CANYON RIDGE VILLAS

**Re: Proposed Canyon Ridge Villas residential development, Atley Road, Arthurs Point
Assessment of Rock-breaking Noise Effects**

**Re: Proposed Canyon Ridge Villas residential development, Atley Road, Arthurs Point
Response to Council RFI**

**Re: Proposed Canyon Ridge Villas residential development, Atley Road, Arthurs Point
Response to additional Council RFI**

Figure 2.1 – Required location of temporary solid site hoardings

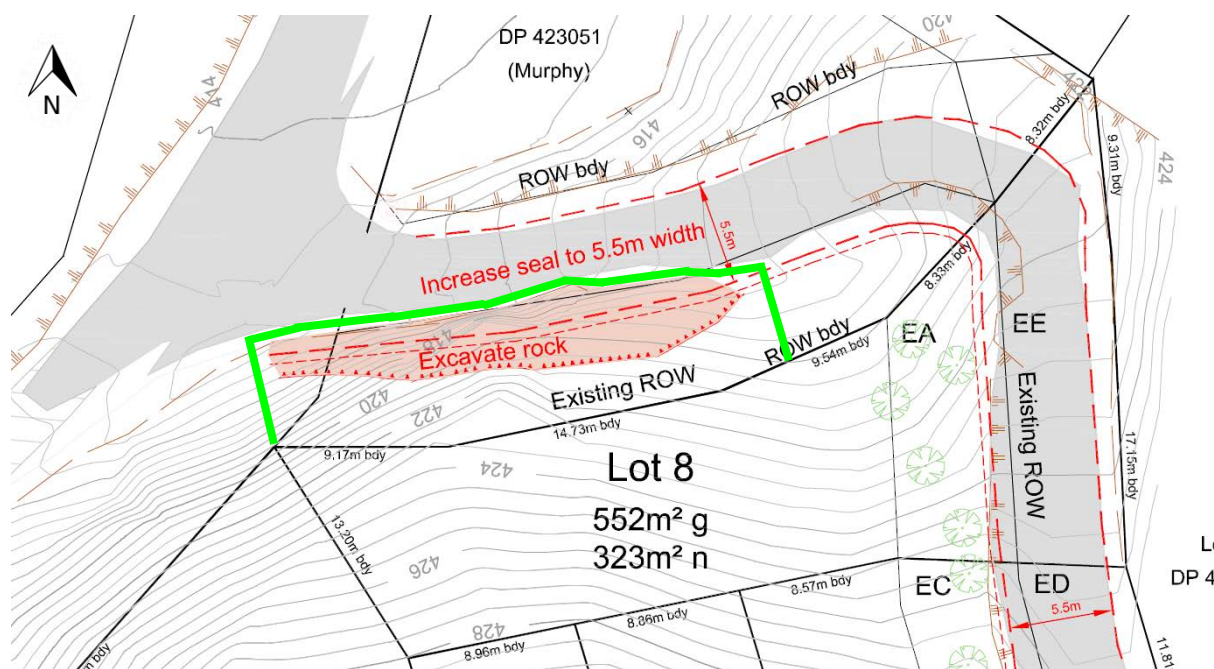
Regarding the widening of the right of way, at the time of our original assessment we were unaware that this process was occurring and had therefore not included it in our analysis and reporting. We have since been provided with a survey plan showing the planned area of rock excavation to accommodate the extra width of the right of way (survey plan titled *Indicative Access Widening, Canyon Ridge, Arthurs Point*, as prepared by Aurum Survey, and dated the 27th of November 2020).

The earthworks plan indicates that the maximum elevation of the work area is 421 metres, with the majority of excavation occurring at an elevation of 418 – 420 metres. While the earthworks plan notes that a 6 metre maximum cut height is expected, this only occurs in a small section of the excavation area. The majority of the excavation area has a cut height of 2 – 3 metres.

We have undertaken additional acoustic modelling based on the excavation area identified in the plan, and a mitigated sound power of 110 dB L_{WA} for the rock breaking equipment as described below. Our analysis had assumed that 2.4 metre high temporary solid site hoardings were installed around the work area as shown in green in figure 2.1 below, with the northern section having an elevation of 418 to 415 metres following the contour of the right of way, and both sides extending up to join the main site boundary at an elevation of 420 metres.

From this, we expect that noise emissions from rock breaking activity associated with the widening of the right of way would be less than 70 dB L_{Aeq} at all neighbouring dwellings. The acoustic screening would need to conform to the minimum standards outlined in section 4.1 of our original assessment.

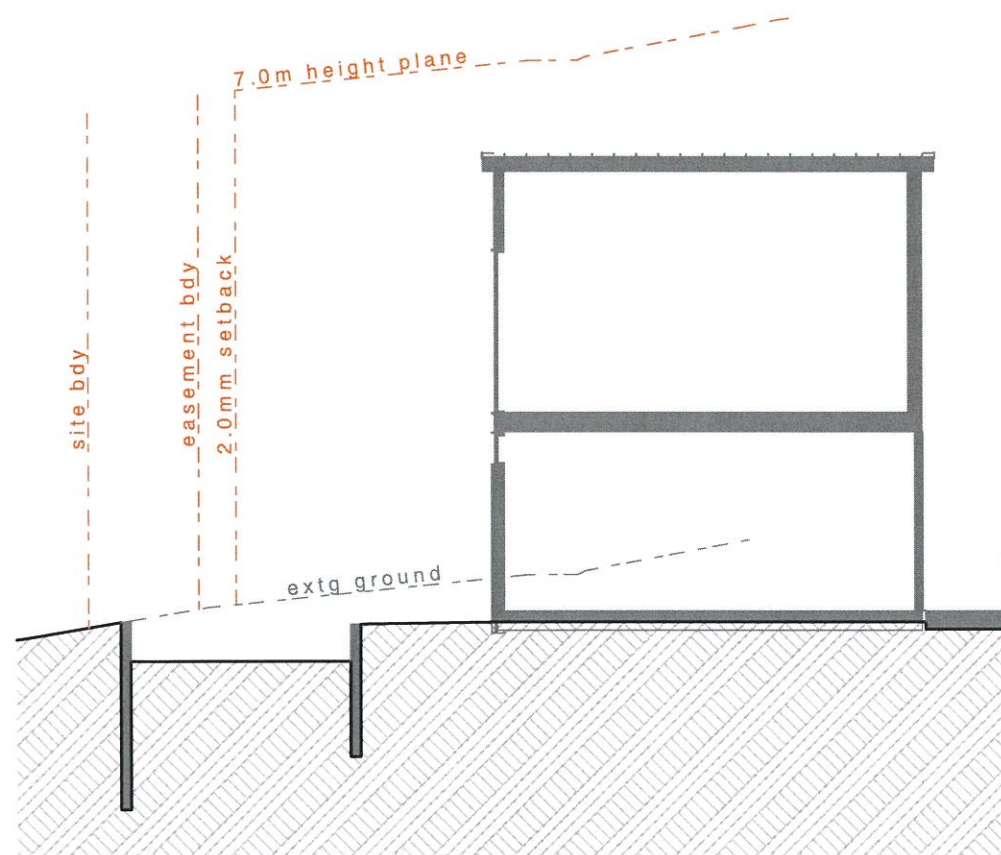
I have reviewed the height limits shown on the Foley Group plans as attached.

You will note there are some differences in the depiction of original ground and the associated height limit on some of the cross sections. This is a result of the location of the cross sections provided by Foley Group differing from my manual review. It is apparent the Foley designs have been undertaken with the correct attention to the maximum building height using a 3D model approach. Given the comprehensive 3D approach their example cross sections are less important, and so do not always show the worst case scenario.

I have analysed the worst case position on the proposed dwellings and conclude the dwellings comply. It can be said that I am in agreement with the Foley cross sections where they are coincident with my review.
